SERVICE BULLETIN

Classification: BT97-017	Reference: NTB97-089	Date: January 1, 1998
-----------------------------	-------------------------	--------------------------

1995-97 MAXIMA INTERIOR SQUEAK AND RATTLE REPAIR

APPLIED VEHICLE: 1995-97 Maxima (A32)
APPLIED VINS: Vehicles built before the VINs from the table below
APPLIED DATES: Vehicles built before the C/M dates from the table below

Figure 1

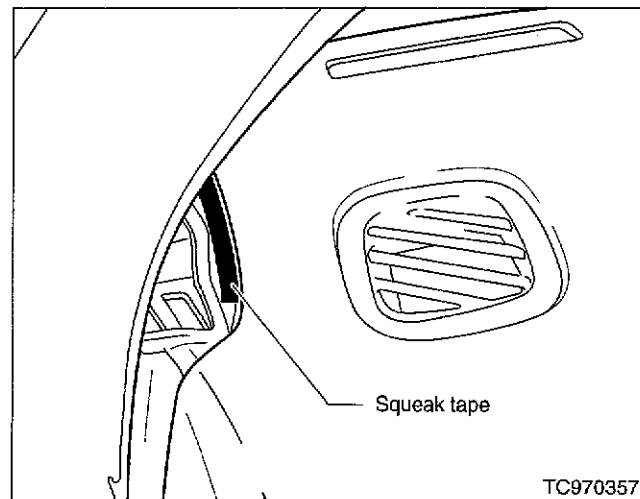
Item	Incident Part	Incident Description	Production C/M Date/VIN	Repair Method
1	A-pillar finisher (either side). GXE & SE models only	Bottom of A-pillar finisher contacts the end of the instrument panel pad.	October 28, 1996 VT218424, VT85288, VM523239	Remove the A-pillar finisher. Add squeak tape to the end of the instrument panel as shown (see Figure 1). Replace the A-pillar.

Figure 2

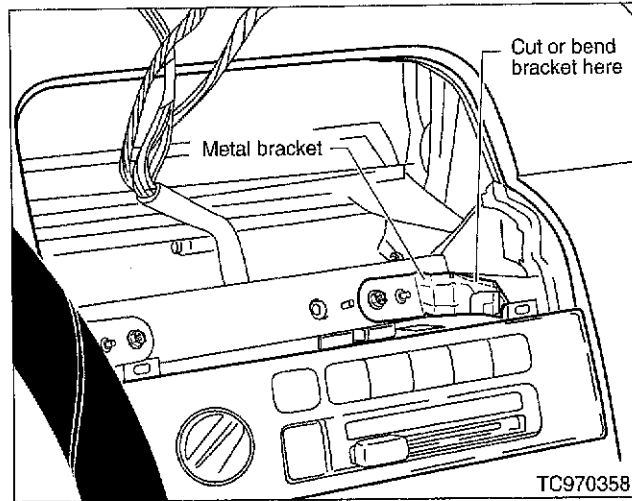
Item	Incident Part	Incident Description	Production C/M Date/VIN	Repair Method
2	Hazard warning switch	The switch may contact the metal bracket for the HVAC/audio head units.	April 25, 1997 VT860216, VT219864, VM527418	Remove the HVAC/audio assembly. Cut or bend the metal bracket to prevent interference with the hazard warning switch as shown (see Figure 2). CAUTION: Make sure no trimmed pieces fall onto the HVAC/audio head.

Figure 3

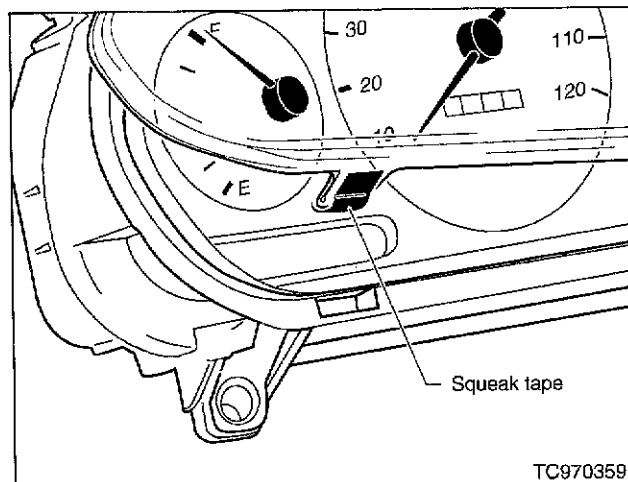
Item	Incident Part	Incident Description	Production C/M Date/VIN	Repair Method
3	Instrument housing and cover	The fit is loose between the clear plastic tab and the housing slot.	August 1, 1995 TT122422, TT710674, TM400038	Remove the instrument cluster bezel. Add squeak tape to the clear plastic tabs as shown (see Figure 3). NOTE: Use a dry cloth to wipe clean the inside of the instrument cover.

Figure 4

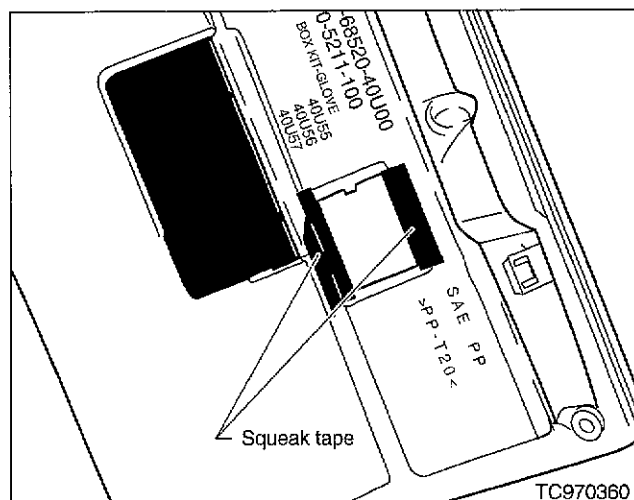
Item	Incident Part	Incident Description	Production C/M Date/VIN	Repair Method
4	Glove box lamp housing	The fit is loose between the lamp housing and the glove box.	October 30, 1996 VT824796, BT211431, VM506150	Remove the glove box. Remove the lamp housing. Add squeak tape to the opening for the lamp housing as shown (see Figure 4).

Figure 5

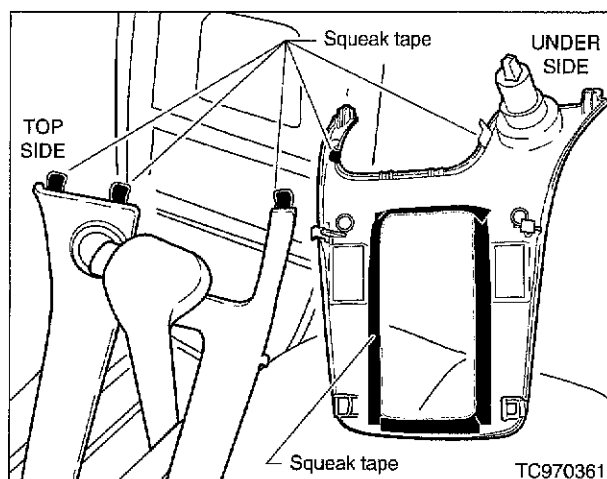
Item	Incident Part	Incident Description	Production C/M Date/VIN	Repair Method
5	A/T shifter finisher	The A/T shifter finisher contacts the A/T shift indicator bezel.	None	Remove the A/T shifter finisher. Add squeak tape to underside of the A/T shifter finisher in two different areas as shown. Also add squeak tape to the topside tabs as shown (see Figure 5).

Figure 6

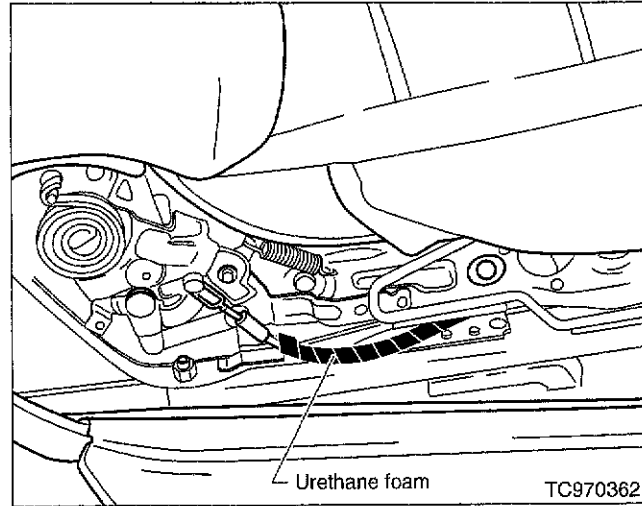
Item	Incident Part	Incident Description	Production C/M Date/VIN	Repair Method
6	Passenger side seat recliner cable Manual passenger seat only	Passenger side seat recliner cable contacts the side cushion finisher.	None	Remove the lower seat finisher. Wrap urethane foam around the recliner cable as shown (see Figure 6).

Figure 7

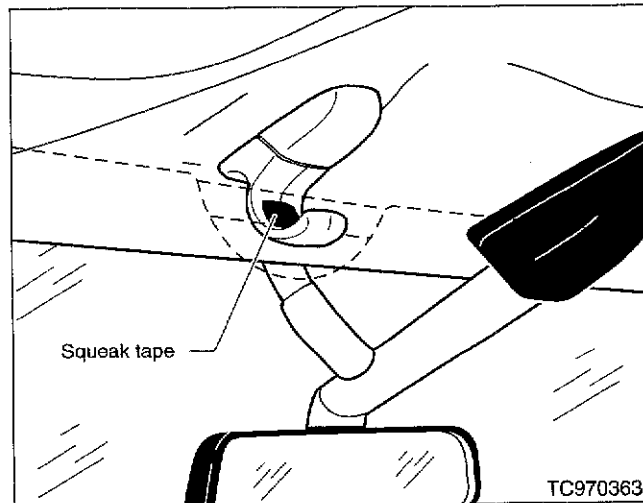
Item	Incident Part	Incident Description	Production C/M Date/VIN	Repair Method
7	Sun visor	Excessive clearance between the sun visor holder clip and the sun visor rod.	None	Add squeak tape to the bottom of the inside of the clip as shown (see Figure 7).

Figure 8

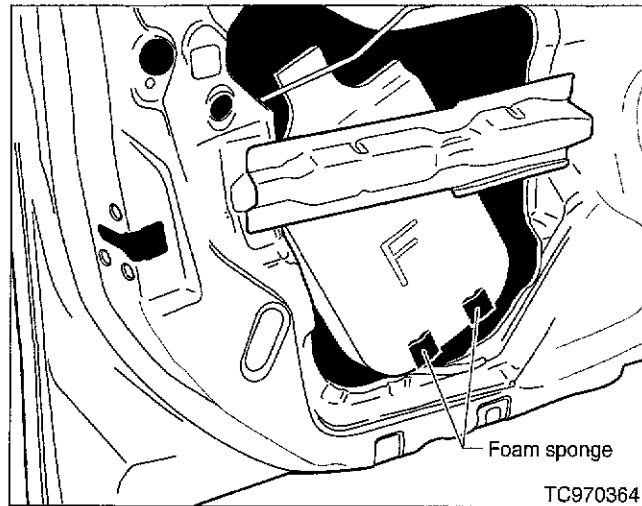
Item	Incident Part	Incident Description	Production C/M Date/VIN	Repair Method
8	Front door styrofoam side impact absorber	The fit is loose between the ribs on the styrofoam block and the inner door panel.	April 25, 1997 VT865191, VT220646 May 16, 1997 VM532102	Remove the door finisher. Remove the side impact absorber. Add foam sponge to the ribs of the impact absorber as shown (see Figure 8). Reinstall the absorber.

Figure 9

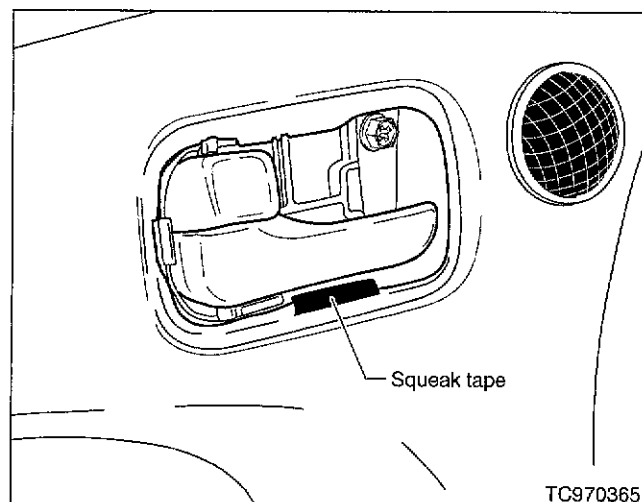
Item	Incident Part	Incident Description	Production C/M Date/VIN	Repair Method
9	Inside door handle finisher	The fit is loose between the inside door handle finisher and the opening for the finisher.	None	Remove the door handle finisher. Wrap squeak tape over the door finisher as shown (see Figure 9).

Figure 10

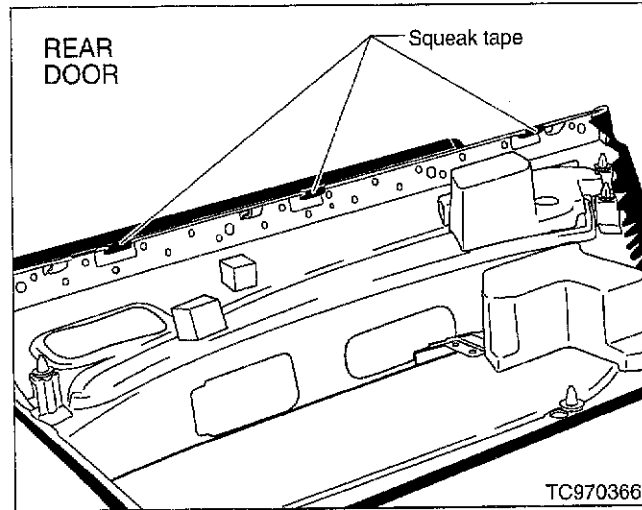
Item	Incident Part	Incident Description	Production C/M Date/VIN	Repair Method
10	Door finisher All	At the window sill area, the existing squeak tape is too thin resulting in a squeak noise when the door finisher rubs against the door inner panel.	August 1, 1995 TT706072, TT104632, TM400038	Remove the door finisher. Remove the existing squeak tape from the three raised areas of the door finisher. Replace with two layers of the squeak tape recommended in this bulletin (see Figure 10).

Figure 11

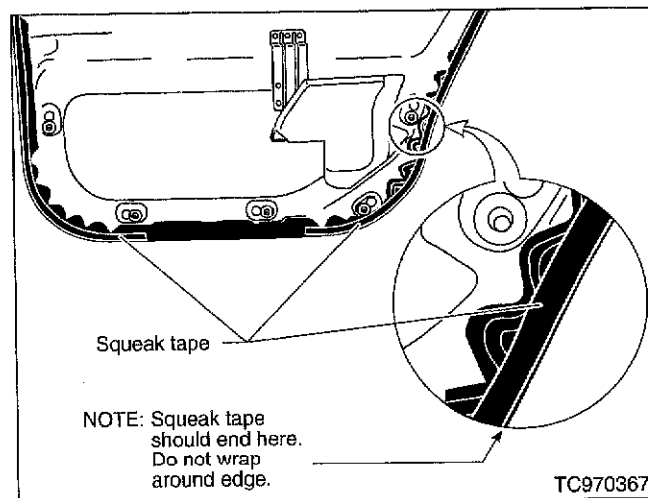
Item	Incident Part	Incident Description	Production C/M Date/VIN	Repair Method
11	Rear door finisher	The existing squeak tape is improperly located on the finisher. This allows contact with the door inner panel.	May 27, 1996 TT175769, TT748571, TM424508	Remove the door finisher. Add squeak tape to the contact area as shown (see Figure 11). NOTE: Do not wrap the tape around the door finisher edge. The tape should not be visible from the outside after installation.

Figure 12

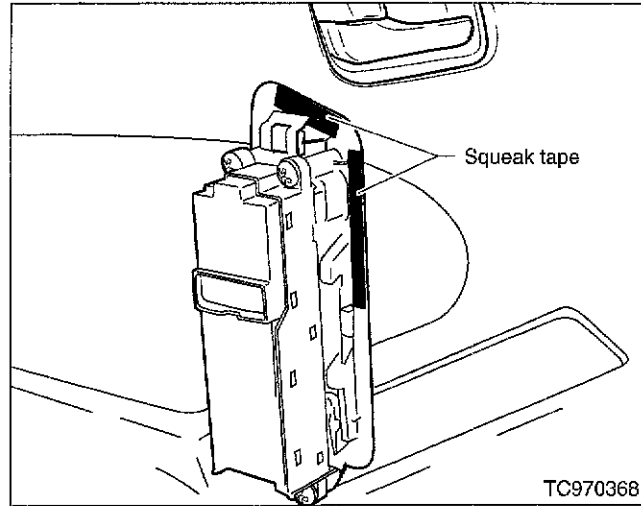
Item	Incident Part	Incident Description	Production C/M Date/VIN	Repair Method
12	Front power window switch finisher	There is intermittent contact between the bottom of the switch finisher and the door finisher.	March 14, 1997 VT854557, VT218791, VM523196	Remove the switch finisher. Add squeak tape to the contact area as shown (see Figure 12).

Figure 13

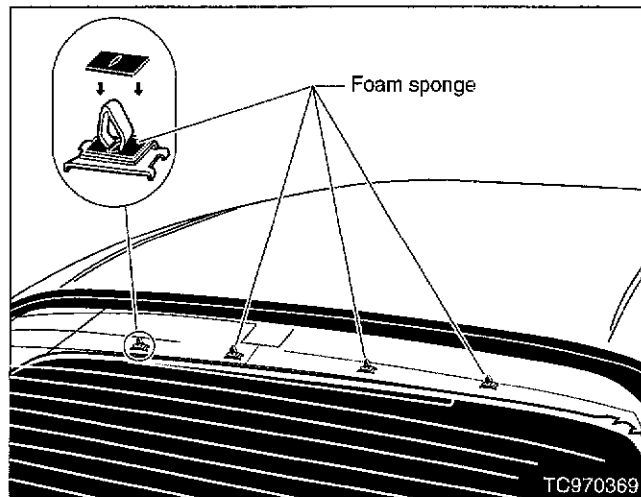
Item	Incident Part	Incident Description	Production C/M Date/VIN	Repair Method
13	Headliner fastener clips	The fit is loose between the headliner fastener clips and the rear window.	February 14, 1997 VT848584, VT218149 April 12, 1997 VM527876	Remove the C-pillar finishers. Carefully pull the headliner down at the rear window. Make squares with the foam sponge (30x30 mm), cut slits in the middle and put over the clips as shown (see Figure 13).

Figure 14

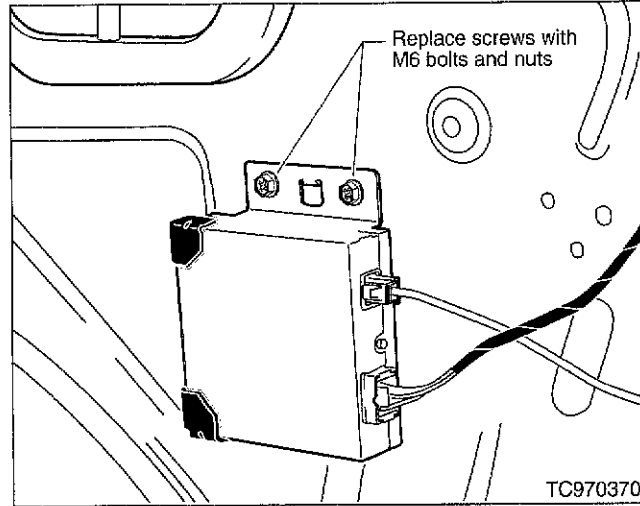
Item	Incident Part	Incident Description	Production C/M Date/VIN	Repair Method
14	Multi-remote lock control unit (LCU05)	Rattle noise near the bottom of the control unit because the screw clamping force is inadequate.	None	Remove the right side trunk finisher. Replace the control unit screws with M6 bolts and nuts (see Figure 14). Torque to specification.

Figure 15

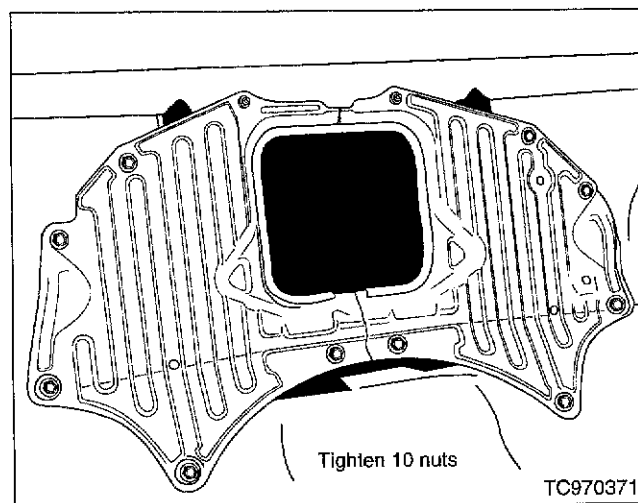
Item	Incident Part	Incident Description	Production C/M Date/VIN	Repair Method
15	Rear seat back support panel nut	The nuts that secure the support panel may be loose. You hear a pop noise when initiating a turn or turning on to an incline (hill or driveway).	October 25, 1995 TT142586, TT731283	Remove the rear seat cushion and back. Torque the 10 nuts to specification (see Figure 15).

Figure 16

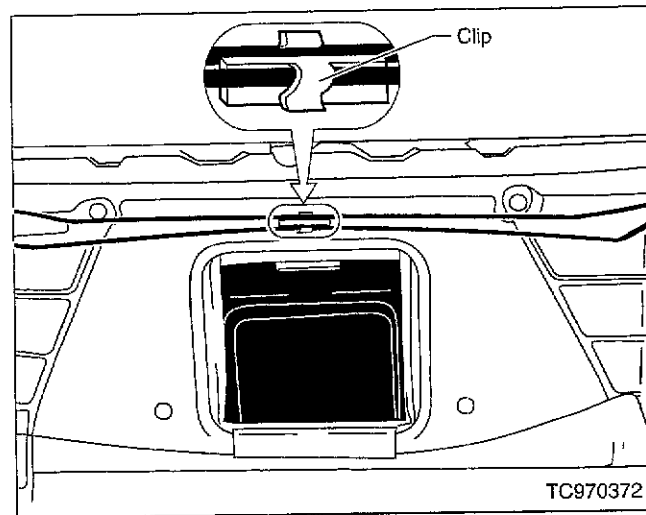
Item	Incident Part	Incident Description	Production C/M Date/VIN	Repair Method
16	Trunk torsion bars	Rattle noise due to intermittent contact between the trunk torsion bars.	October 7, 1996 VT820061, VT208606, VM504366	Add clip (P/N 84437-41L00) to ensure a clearance between the bars (see Figure 16).
